**Damaged Cupholder –  
Replace Mechanism Only –  
Repair Procedure**MODEL 1995-97 MY  
Sedan Range  
VIN 720001-812255**ISSUE:**

ILLUSTRATION 1

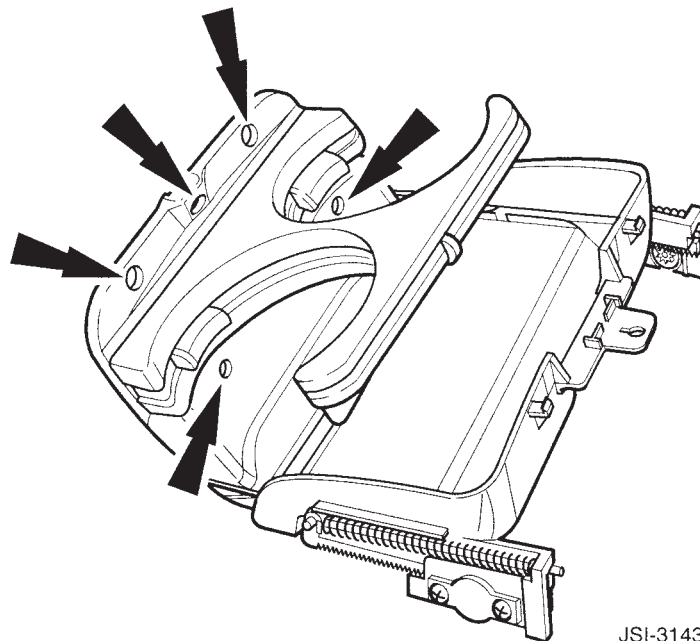
In case of a customer complaint of a broken cup-holder assembly, (shown in Illustration 1), remove the holder and install a new assembly in the cubby box lid as described on the next page.
